Determination 2009/110

Determination regarding access for people with disabilities to a café at 2200 East Coast Road, Silverdale, Auckland

- 2.1 Figures 1 and 2 show the floor plan of the building before and after the alterations.

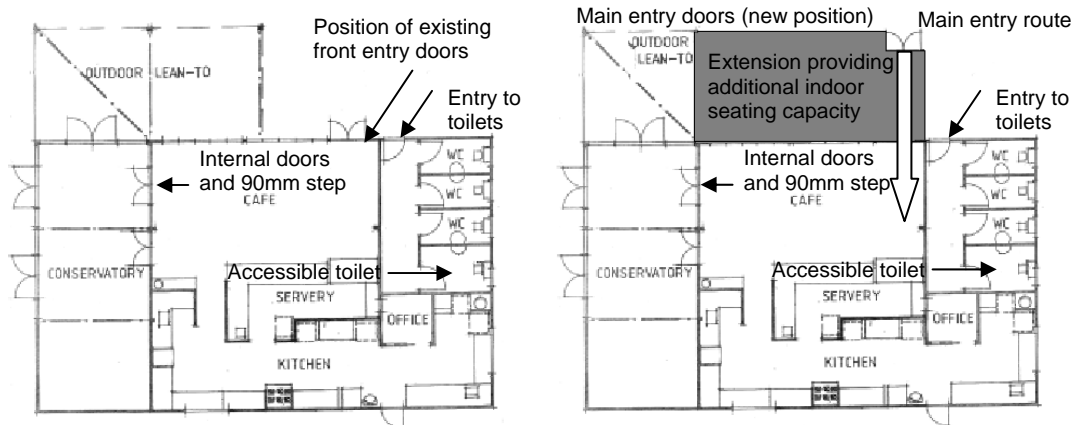
- 2.2 The building work was an alteration to an existing building. The building was extended to enclose an existing outdoor seating area of the café and provide additional indoor seating capacity (“the extension”).
- 2.3 The front entrance doors from the existing building were re-used in the extension at the new entrance, as the main entry doors. There is also an existing entrance at the conservatory. The building has sanitary facilities including an accessible toilet to which the entrance is an external door near the main entry doors.
- 2.4 The main entry doors have an exterior ramp with 1:18 slope, no level landing at the entry door, two 610mm leaves with magnetic latches that are manually operated for opening the doors, and a 30mm threshold.

- 8.1 The main entry route does not comply with Clause D1 because there is no level landing at the door, there is a stepped threshold greater than 20mm and the doors do not have a clear opening of 760mm for one of the leafs.

- 8.6 The ramp, the threshold, and the doors of the main entry do not comply with the Building Code. I note that the fact that the doors were part of the original entrance does not mean they can be deemed acceptable by virtue of section 112. The doors are part of the new main entrance way and are therefore new building work. Without a compliant entry to the café, accessibility is significantly compromised. The new landing and threshold, and the doors, whether new, or reused and modified, needed to have been designed and built to fully comply with the requirements of Clause D1.

- Reduce one door leaf to 400mm and provide a new door at least 760mm wide and preferably 800mm (within the existing frame).
- Provide a 1200mm × 1200mm flat landing outside the doors. Raise the level so that a 20mm maximum threshold is achieved.
- Provide a 1 in 12 maximum ramp to the landing.
